Proposed changes to 802.3ca - D2.0
PMA figures 142-19 & 142-20

Rev. 1a

Bill Powell - FN CTO Group, Raleigh

Proposed changes to D2.0 PMA Figures 142-19 & 142-20

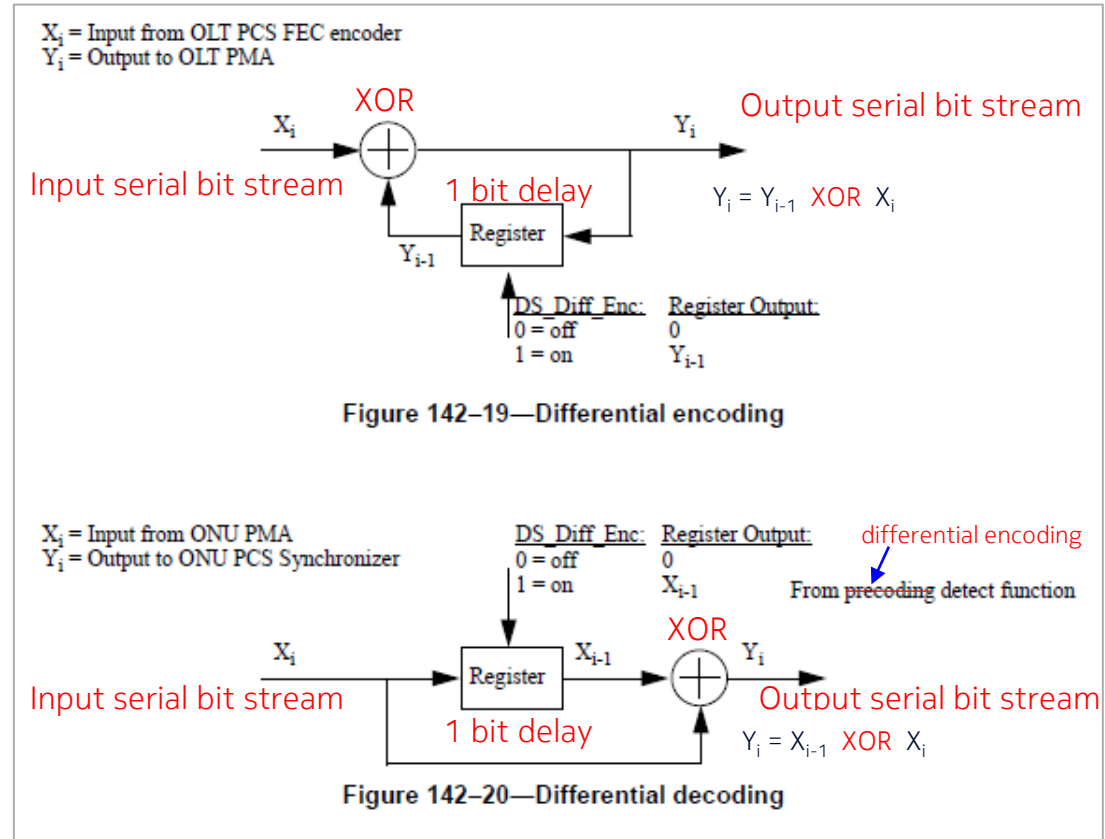
- Propose to add notes to Figures 142-19 and 142-20 to address concerns raised in comment #387

Current D2.0 PMA figures (black) & proposed changes (Red)
